Office Action Summary	Application No. 10/767,199	Applicant(s) DOWNING ET AL.	
	Examiner Charlie Peng	Art Unit 2883

DETAILED ACTION

**FIG. 1A**

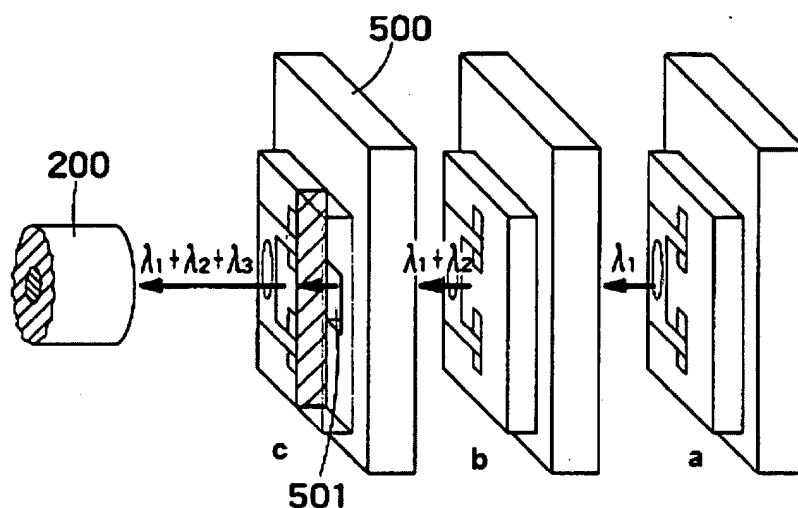
Claims 1, 2, 4-8, 11-13, and 16 are rejected under 35 U.S.C. 103(a) as being unpatentable over U.S. Patent 6,081,636 to Kinoshita. Kinoshita teach a plurality of laser elements **a, b, c** arranged coaxially and substantially abutting; the laser elements, having different periods of diffraction gratings to oscillate at different wavelengths λ_1 , λ_2 , λ_3 , respectively, are arranged coaxially with output light and collectively coupled to a fiber 200 by laser **c**; each laser element is formed on a heat sink **500**; and anti-reflective coatings 6' (an AR coating merely reduces reflection, i.e. by destructive interference, and not completely eliminate reflection, so an AR coating is still a reflective coating to a range of frequency or wavelength) are applied on front and back surfaces of each laser element. (See at least attached Fig. 1A with additional annotations and description) Kinoshita does not teach the laser elements **a, b, c** to be placed on a common support substrate. However, in a separate embodiment as illustrated by Fig. 3, Kinoshita places three laser elements emitting light of different wavelengths on a single support **1**. It would have been obvious to one of ordinary skill in the art at the time the invention was made to place all the laser elements on a single support layer. The motivation would be to provide compact arrangement of lasers and reduce the size and the number of the optical components used.

With specific reference to claim 4, since the three diode lasers **a**, **b**, **c** share one output facet of the laser **c**, their output diffraction properties are based solely on the output facet of the laser **c** and therefore identical.
